SONY® Service Bulletin

NO: ME3-99-009

SUBJECT: POOR DISPLAY LEGIBILITY

MODEL (S): MDX-C670

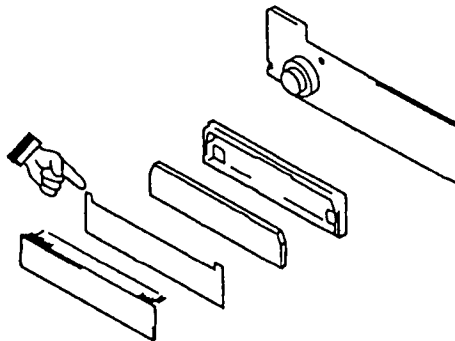
SYMPTOM: The display is hardly legible in bright sunlight.

CAUSE: Insufficient illumination.

SOLUTION: Replace the "Sheet (Diffusion)" with the improved part 3-020-025-01.
